**Engineering Change Request (ECR) Okt-2018 – DT750 BLE
TCN015 + 5103A-015**

Modification of antenna pcb

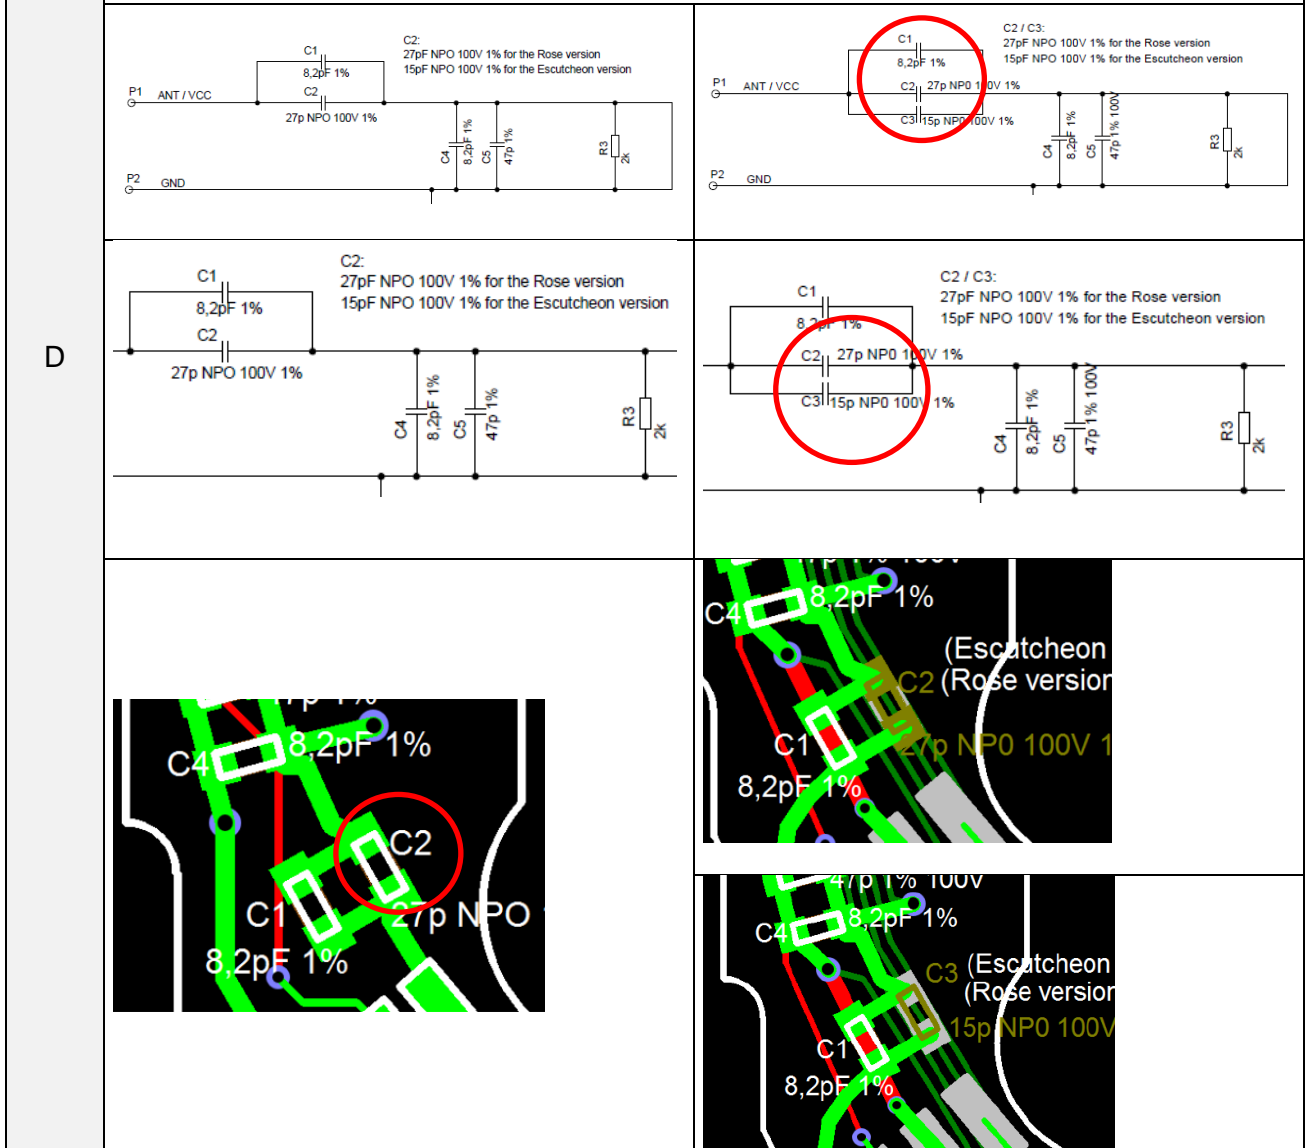
Old	New
Part	SHS-90 V1.5	SHS-90 V1.5
A	No changes	
Part	SHS-92 V1.2	SHS-92 V1.4
A	<p>Changed order of P1 to P4</p> <p>Cause of the Modification: Better cable routing</p>

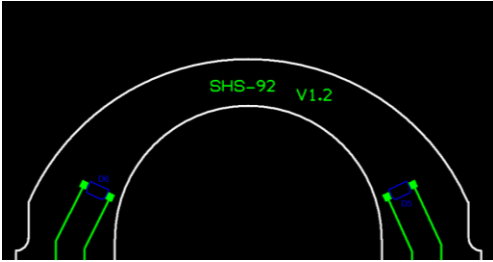
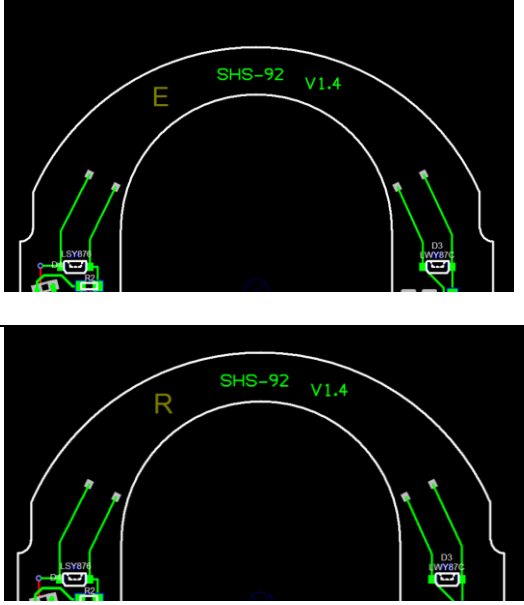
C3 for Escutcheon version added. C2 and C3 share the same pcb position. It is not possible to place both at the same time.

This change results in two different BOMs:

- 3.164.022.60c BOM SHS-92 V1.4 (Rose version)
 - C2 included
 - C3 not included
- 3.164.022.60c BOM SHS-92 V1.4 (Escutcheon version)
 - C2 not included
 - C3 included

Cause of modification: Optimization of BOM handling

E	added "E" / "R" in the silkscreen layer of the pcb Cause of modification: Optimization of pcb handling in production
